MEMO FROM COUNCIL OFFICE:

Re: Ordinance 2024-07 - To Amend the City of Bloomington Zoning Maps by Rezoning A 138.51 Acre Property From Planned Unit Development (PUD) And Residential Medium Lot (R2) to Planned Unit Development (PUD) And to Approve a District Ordinance and Preliminary Plan – Re: S. Weimer Road (Sudbury Partners LLC, Petitioner)

Ordinance 2024-07 would rezone a 138.51 acre property from Planned Unit Development (PUD) and Residential Medium Lot (R2) to a Planned Unit Development (PUD) and approve a PUD District Ordinance and Preliminary Plan.

2. ELECTRIC VEHICLE PARKING CHARGING STATIONS

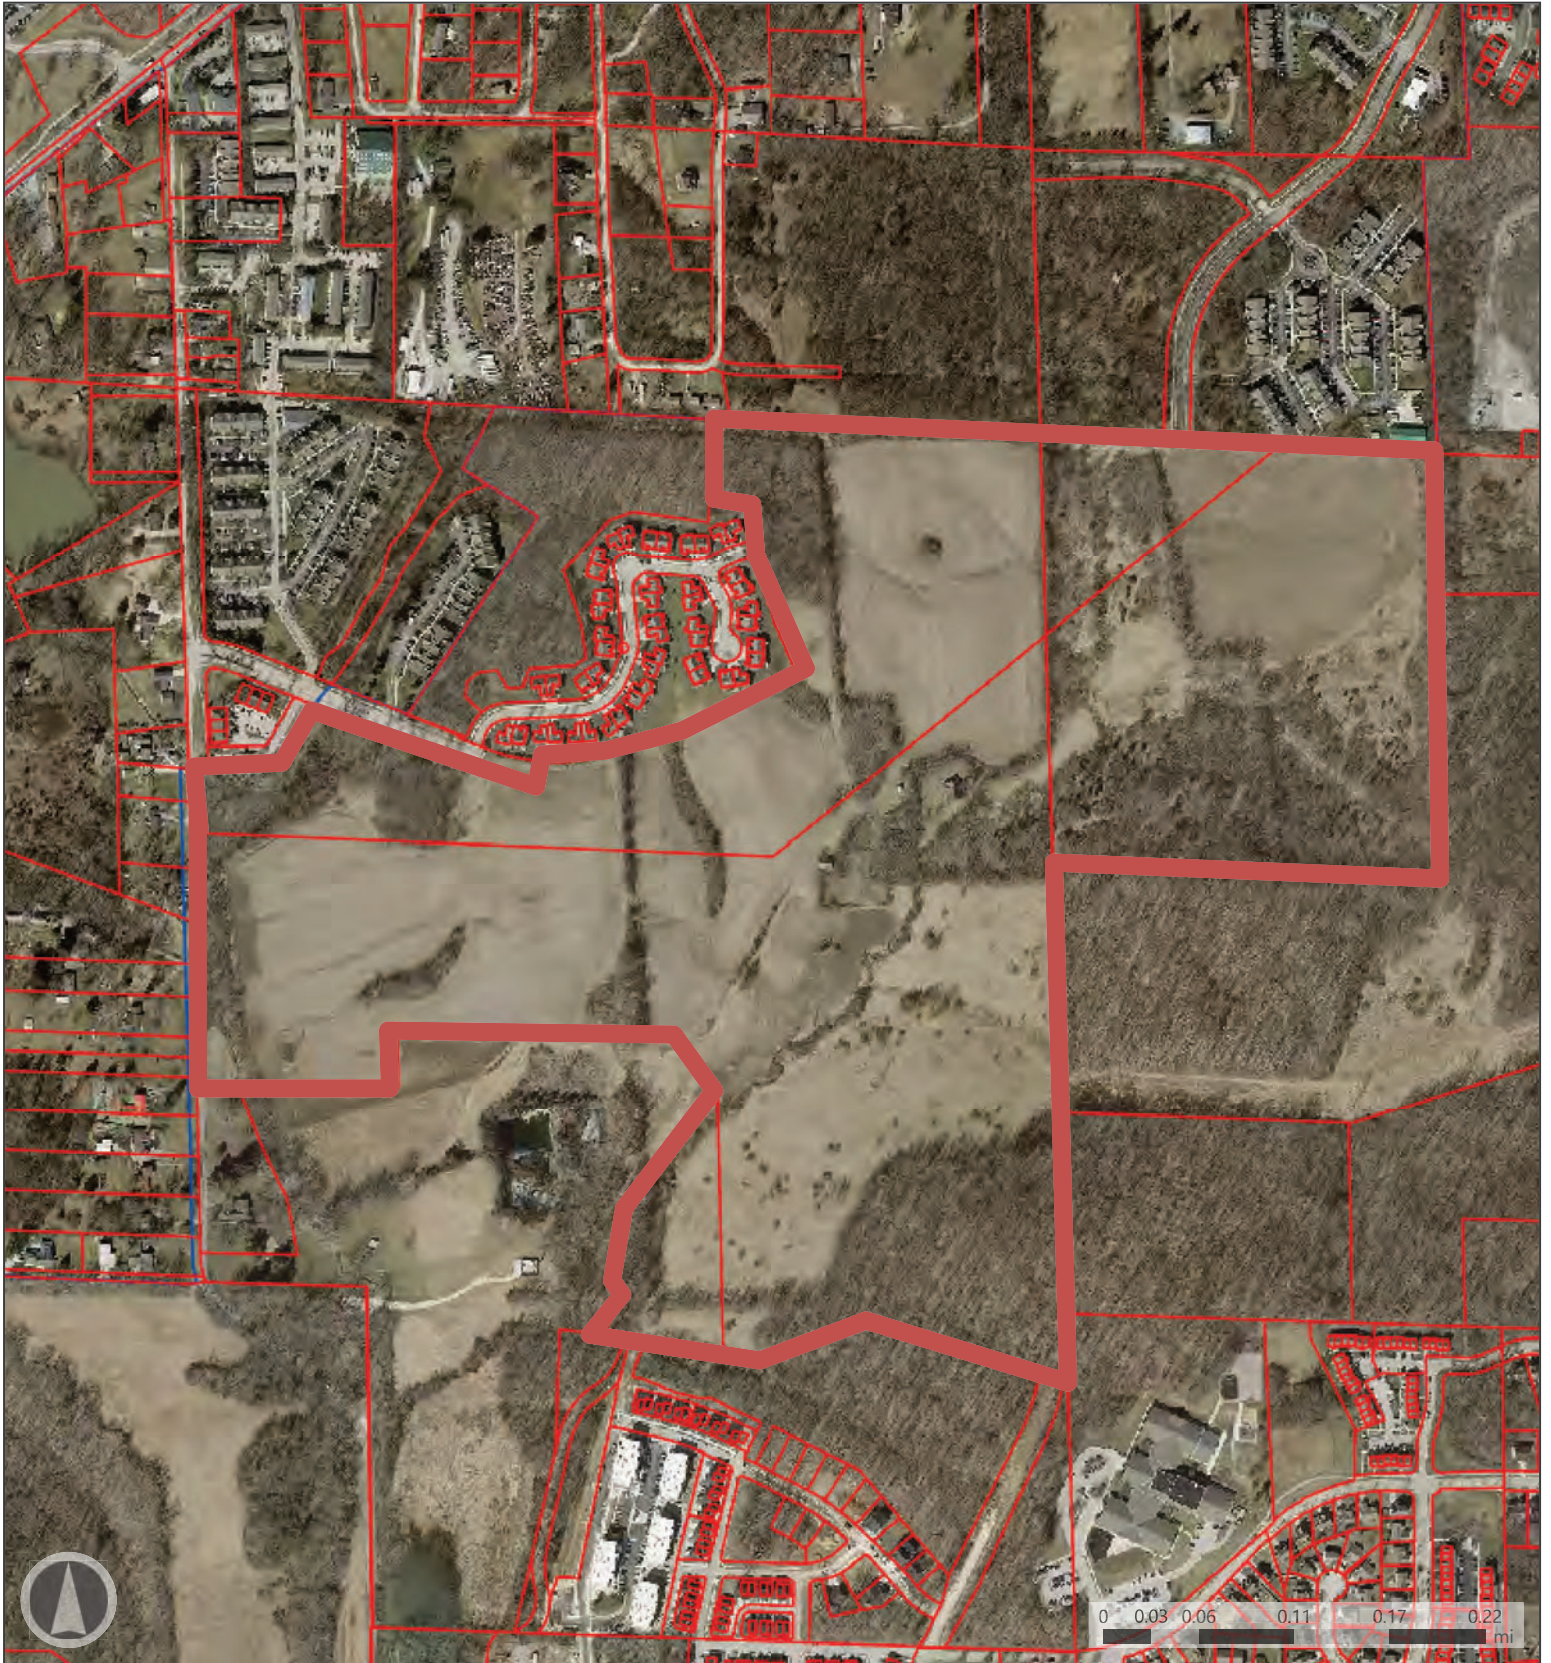
Even though the Petitioner proposes the same number of electric vehicle (EV) parking sites as required by the UDO, the EC believes they need more. Instead of two EV spaces per fifty regular spaces, the EC suggests four EV spaces per fifty regular spaces.

Figure 1. Summit District PUD nearby streets. Red circles are anticipated choke points.

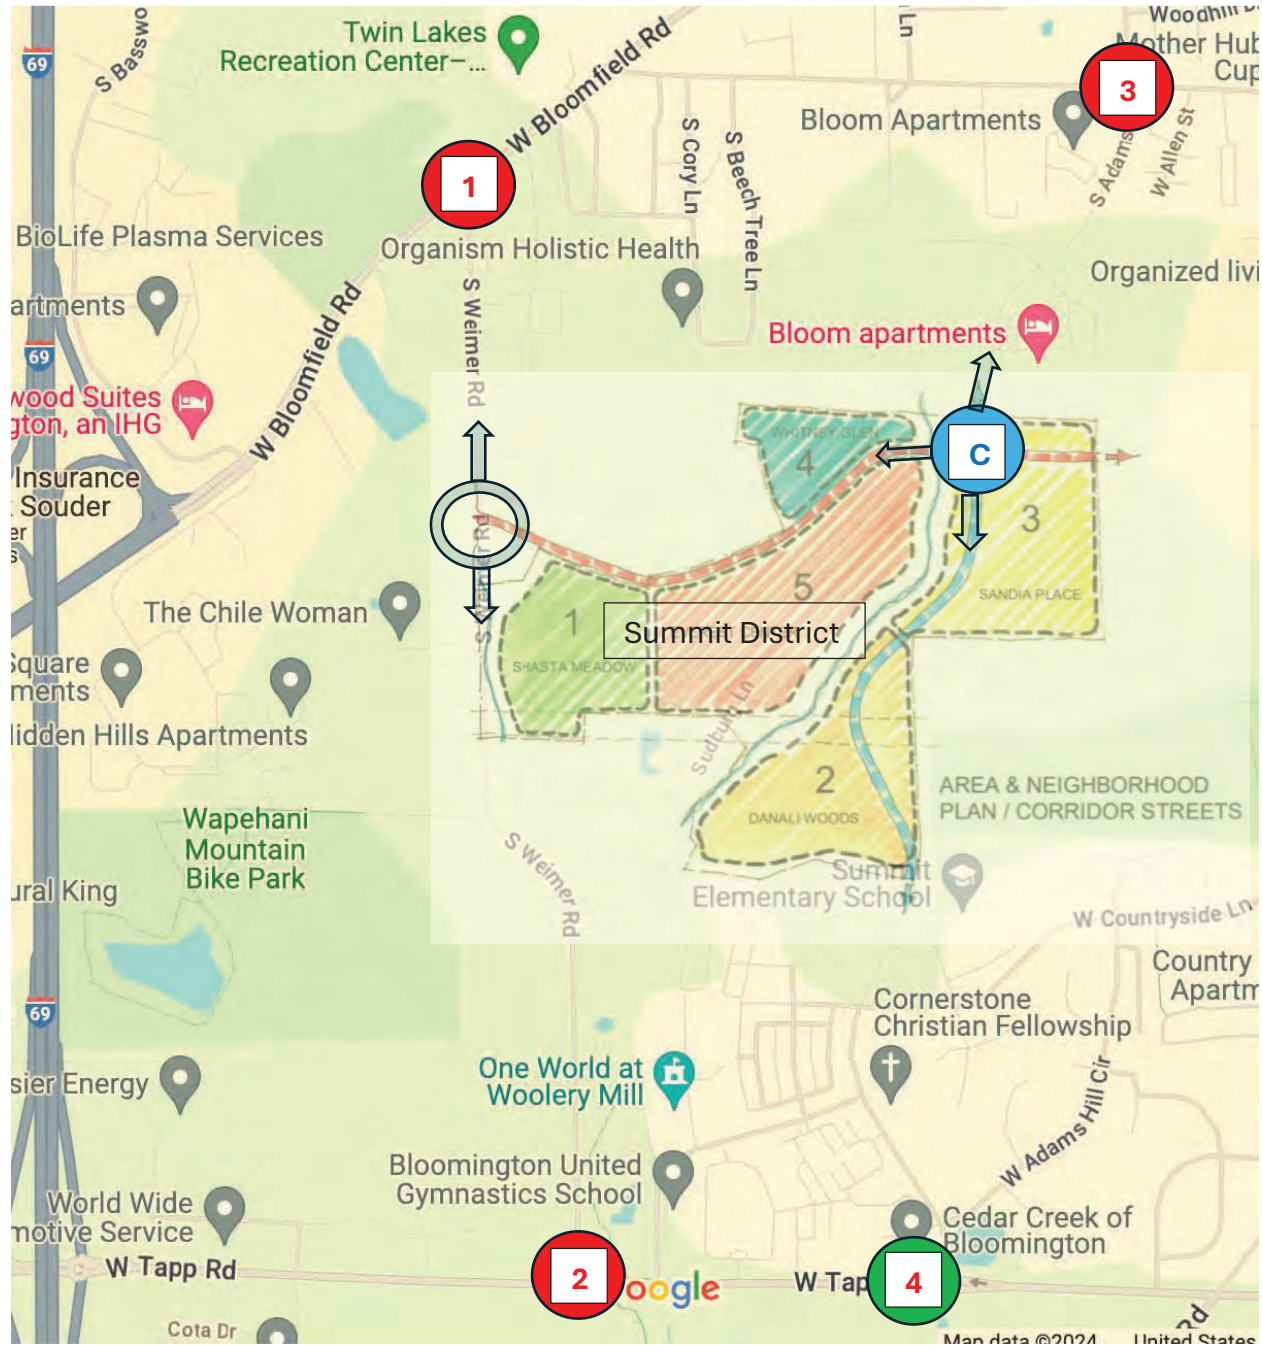
great as the city of Martinsville. While these are ballpark estimates, they do put things into perspective, as Table 1 shows. And this will impact traffic congestion, because currently there are only 4 main ways to get in or out of the Summit PUD area to nearby main arterials (Tapp Rd. and Bloomfield Rd.). Note that S. Adams intersects with W. 2nd St where there is currently a stoplight, which is north of the Adams and Allen St. intersection at circle 3.

Image A*. COBERI Figure 5 of karst areas in southwest Bloomington in 2003. Superimposed is Image One from the Bloomington Plan Commission staff report in the BPC meeting packet for Sept. 11, 2023.

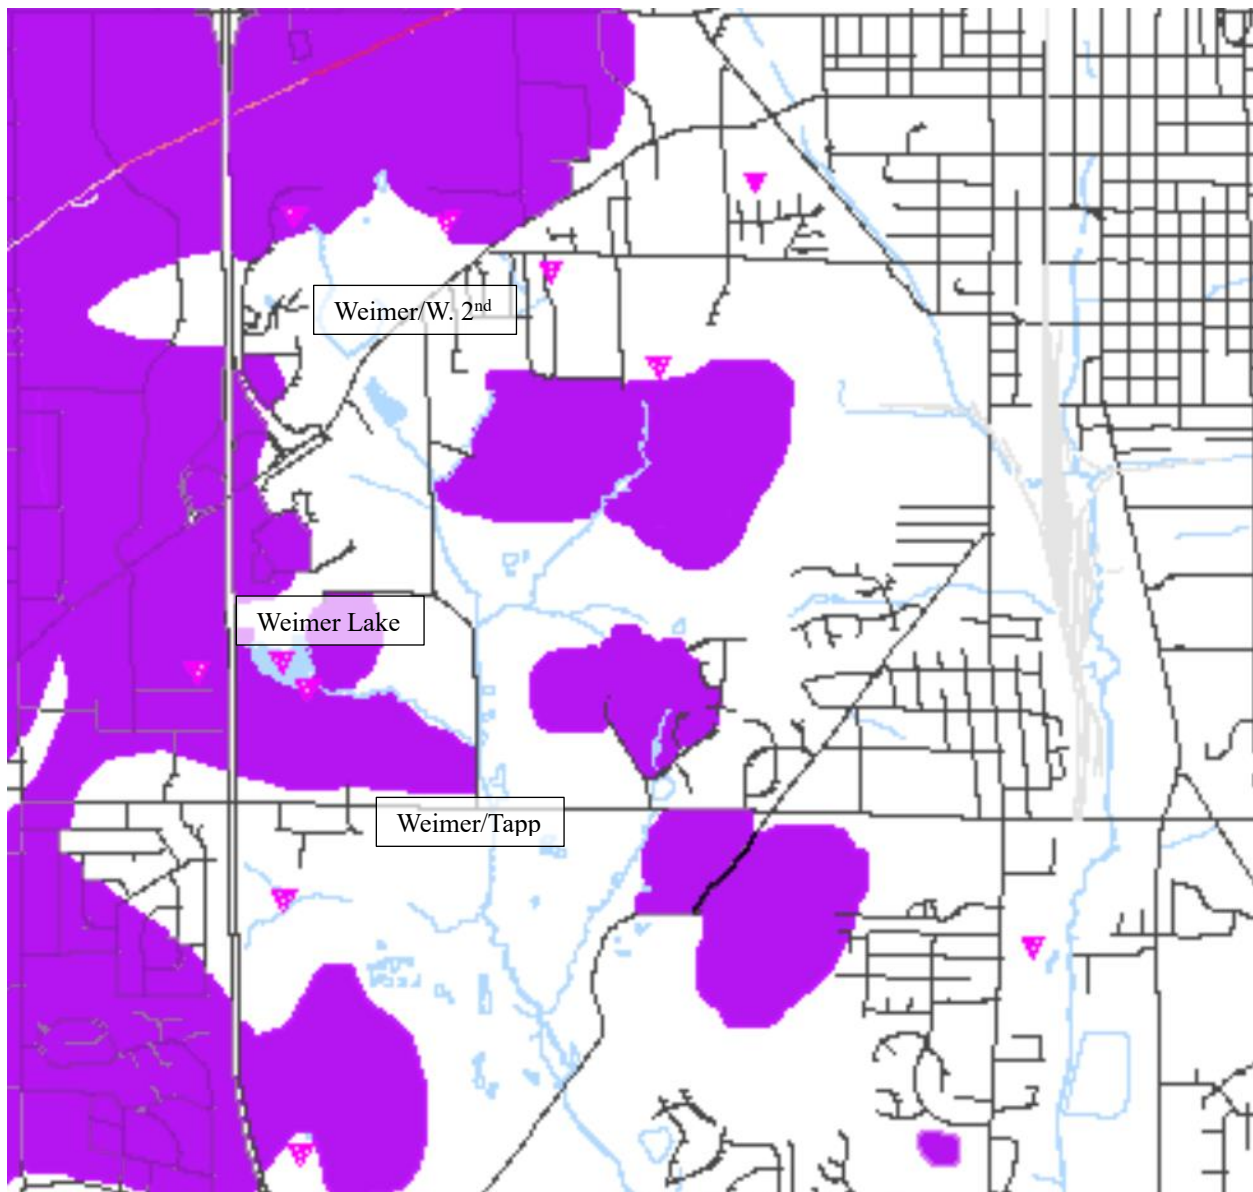
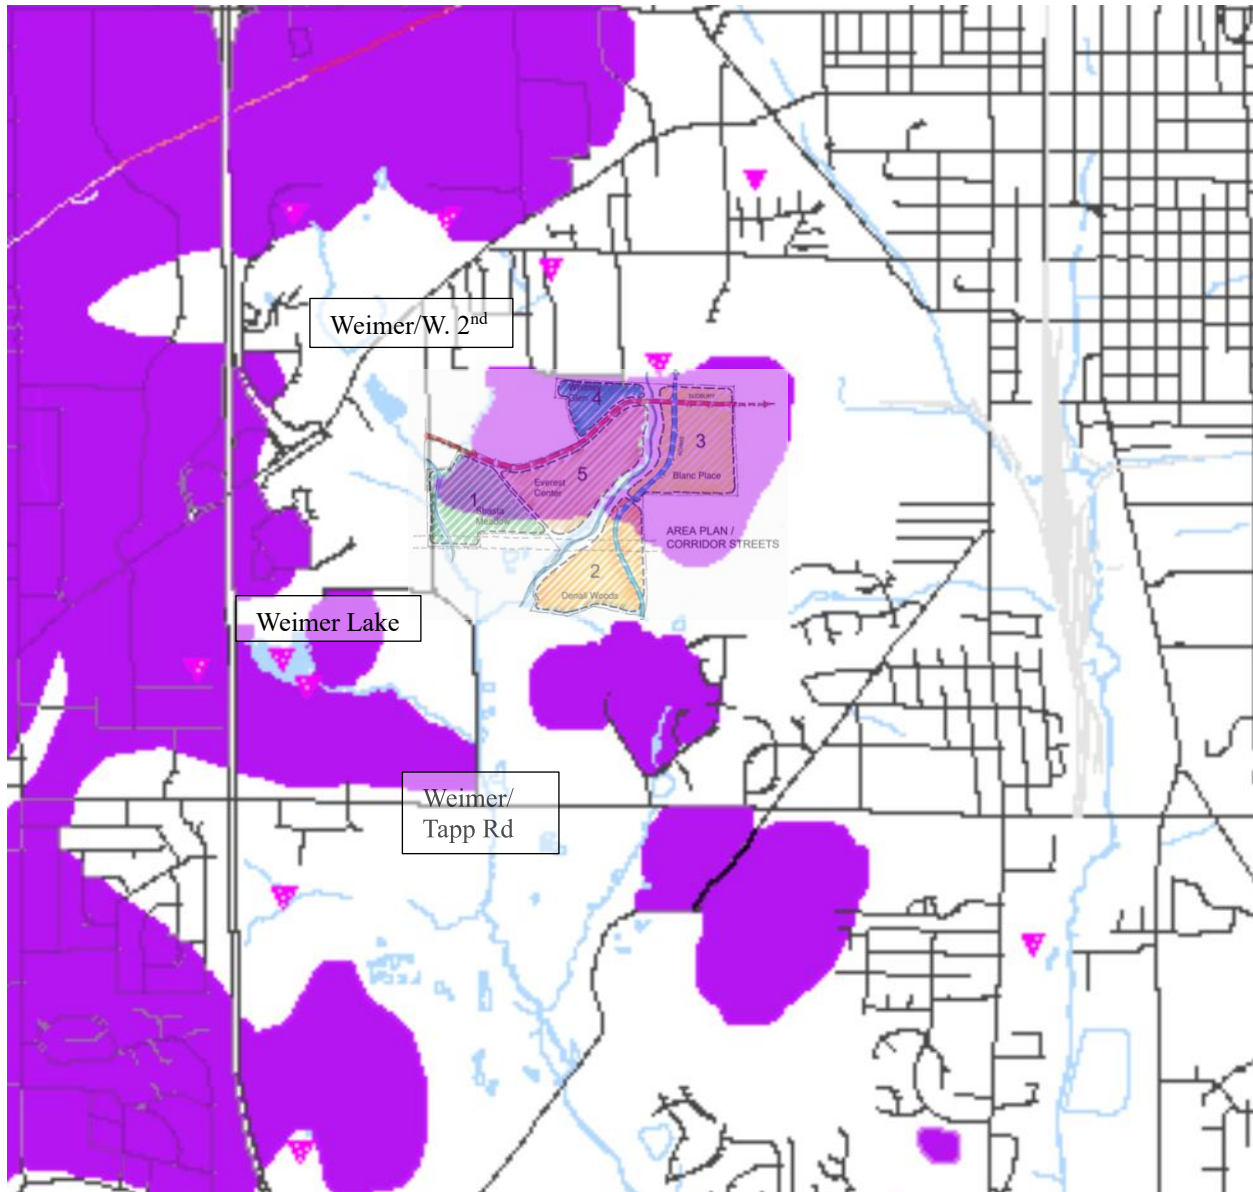
A number of sinkholes were reportedly located within the PUD, especially at the higher elevations of the Summit District. See Stantec's Environmental Constraints report in the BPC meeting packet: https://bloomington.in.gov/onboard/meetingFiles/download?meetingFile_id=13177. It is evident in map EX-8 (p. 107) that bedrock is typically 3 to 5 feet below the surface in much of the PUD area in the higher elevations, and Image A* indicates that this is mostly karst. Although the Summit District PUD indicates preservation and protection of 48 existing sinkholes identified in EX-8, **the fact remains that much of the development would be on top of or may need to cut into existing karst bedrock identified in the COBERI and Stantec reports.**
